AGENDA
Regular Hybrid Meeting
Town of Granby
Inland Wetlands and Watercourses Commission
Wednesday, August 13, 2025, at 7:00 pm
Town Hall Meeting Room

MEETING MINUTES
Town of Granby
Inland Wetlands and Watercourses Commission
Wednesday, July 9, 2025, at 7:00 pm

This letter is being submitted by Kimley-Horn & Associates, Inc. on behalf of AutoZone, Inc. ("Applicant") in response to the department review letters listed below:

SHEET NUMBER
C-3.0

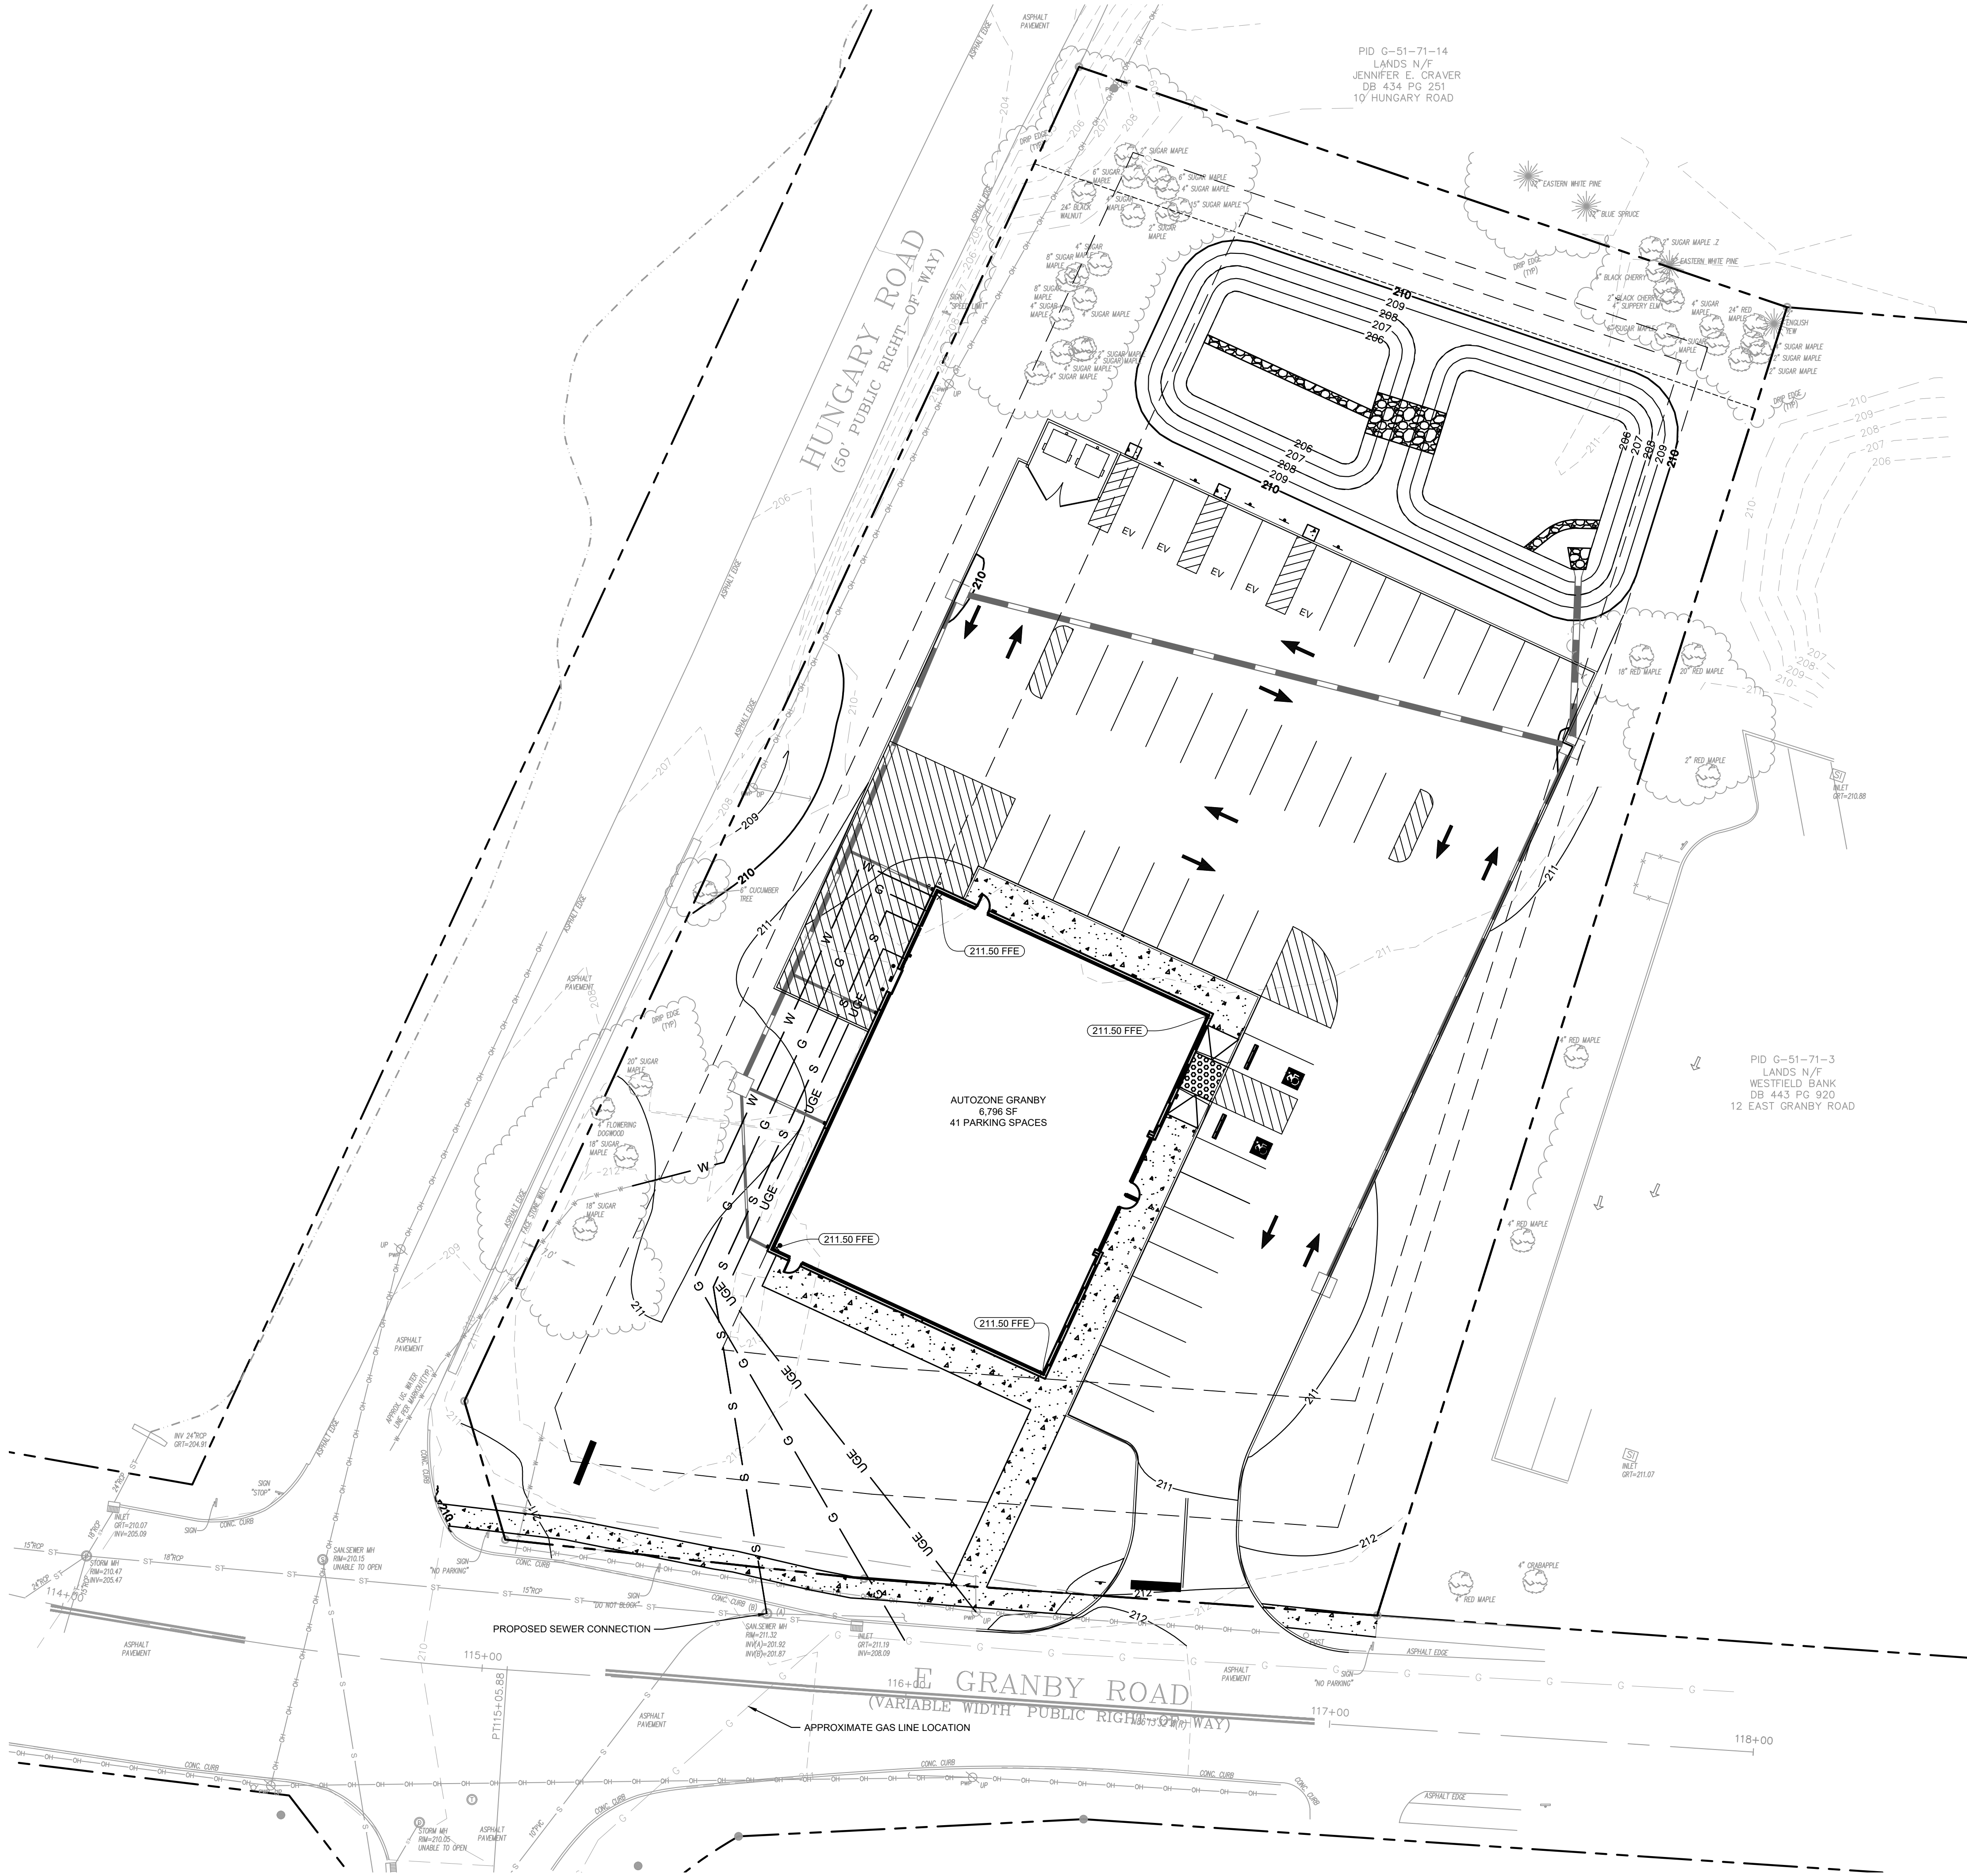
Sheet C-3.0

2. Show test hole information on this sheet.

3. Add the test hole pit data to the report and on sheet C-3.0. Test pits and soil data reporting to comply with the Connecticut Stormwater Quality Manual, March 30, 2024, Chapter 10, Test pits and Borings, pages 178 and 179.

Response: Sheet C-3.0 has been revised to include the test pit information (testing elevation and infiltration rate).

Response: Test pit data is included in the SWMP on page 14 and the full geotechnical report is provided in Appendix A.

Per the CT Stormwater Quality Manual, if the infiltration rate exceeds 8.3 in/hr, then 100% of the stormwater quality volume requirement must be treated using a different stormwater management practice before entering the infiltration basin. Therefore, the project stormwater management plan has been revised to include a bioretention basin before the

infiltration basin to treat the required water quality volume. The provided site plans and SWMP have been revised to include the bioretention location and details.
